Access Compliance Report

Public Rights-of-Way

(Curb Ramps)

| Intersection ID: 8620 | Main Street: DUPREE_ST | Cross Street: HONEYWOOD_AV | Location: | N |

| ADA ID: DE63B3213CA8 | Ramp Type: Perp | Initial Pass/Fail: Fail | Overall Compliance: No | Severity Score: 21.25 |

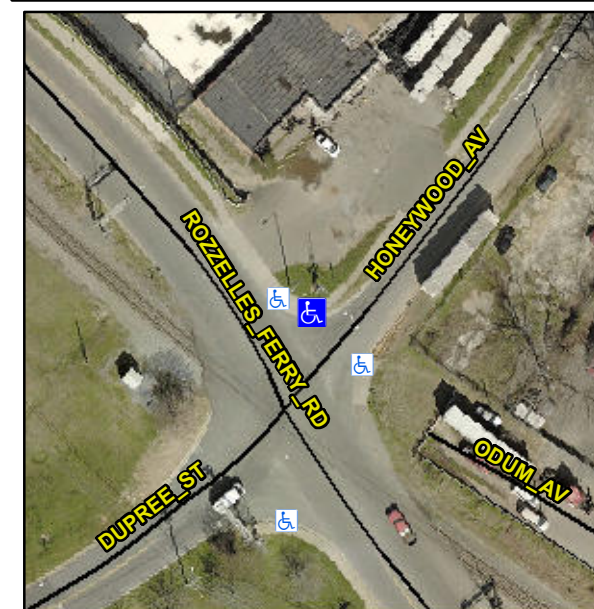
Not Found, R304.5.1, R304.5.3

| Compliance | Description | Data | Compliance | Description | Data |
|------------|-----------------------|------|------------|-----------------------------|------|
| No | Ramp Width (in) | 43.0 | No | Ramp XSlope (%) | 5.1 |

Remove & Replace Entire Ramp.
